MATERIAL		DRAWN BY	Jack.Seeley	03/02/2020
THICKNESS		CUSTOMER	NEBRA (PI SUPPLY)	
www.smartboxx.co.uk		PART NO.	4645 (GA) -02	
		REV 02	SCALE: 1:2	SHEET 1 OF 1
				A4

DETAIL B

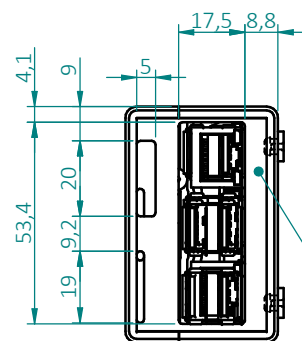
1.0 x 45° CHAMFER in the place of the 1.5mm Roundover to limit scratching.

DETAIL A

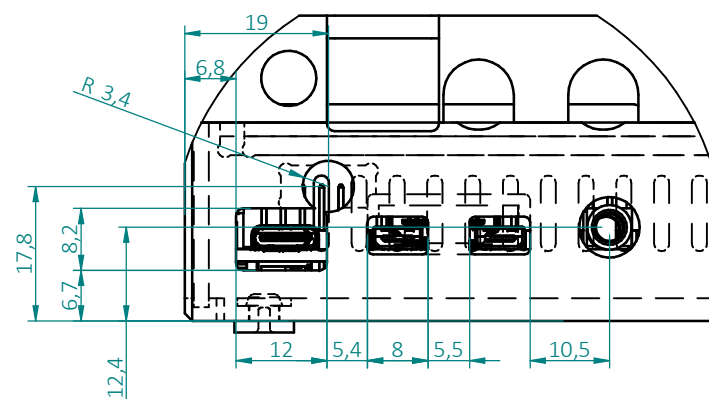
Front panel slot added to accomodate Pi 3 and Pi 4 in the end panel. This would decrease the strength of the panel so could look at bonding this to the base.
